Access Compliance Report

Public Rights-of-Way

Intersection ID: 10037210	Main Street: SANDY_ROCK_PL	Cross Street: N/A	Location: SE
ADA ID: 56B32BD36394	Ramp Type: PerpDiag	Initial Pass/Fail: Fail	Overall Compliance: No
		Severity Score: 12.5

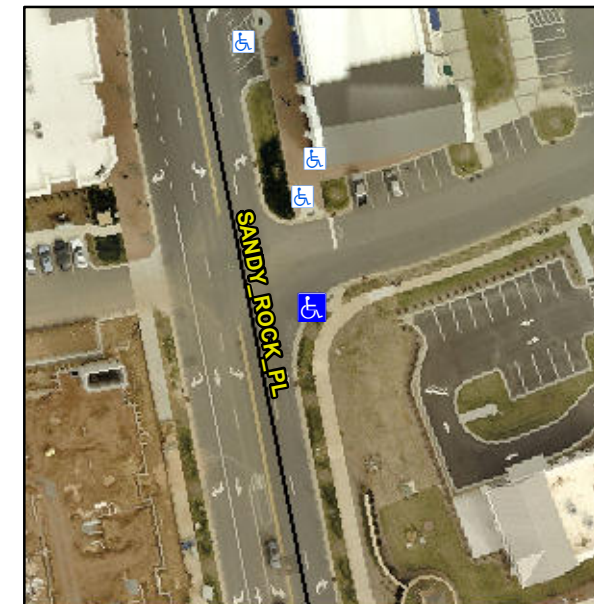
Not Found, R304.5.3

Compliance	Description	Data	Compliance	Description	Data
N/A	Ramp Length (in)	95.0	Yes	Ramp Slope (%)	5.7
Yes	Ramp Width (in)	60.5	No	Ramp XSlope (%)	6.8
N/A	Flare Type LT	N/A	N/A	Flare Type RT	N/A
N/A	Flare Slope LT (%)	N/A	N/A	Flare Slope RT (%)	N/A
N/A	Flare Traversable LT?	N/A	N/A	Flare Traversable RT?	N/A
N/A	Landing Length (in)	N/A	N/A	DWS Provided?	N/A
N/A	Landing Width (in)	N/A	N/A	DWS Contrast?	N/A
N/A	Landing Slope (%)	N/A	N/A	DWS Length (in)	N/A
N/A	Landing X Slope (%)	N/A	N/A	DWS Full Width?	N/A
N/A	Landing Curb? (Y/N)	N/A	N/A	DWS Offset (in)	N/A
N/A	Shared Landing?	N/A			
N/A	Gutter Ponding?	N/A	N/A	Gutter Slope (%)	N/A
N/A	Gutter Lip Ht (in)	N/A	N/A	Gutter X Slope (%)	N/A
N/A	Painted X Walk1?	No	N/A	Painted X Walk2?	No
	X Walk 1 Direction	To N		X Walk 2 Direction	To W
N/A	X Walk 1 Width (in)	N/A	N/A	X Walk 2 Width (in)	N/A
	X Walk 1 Slope (%)	3.1		X Walk 2 Slope (%)	2.8
	X Walk 1 X Slope (%)	2.8		X Walk 2 X Slope (%)	1.7

Remove & Replace Curb Ramp With Two New Directional Ramps or Equivalent.
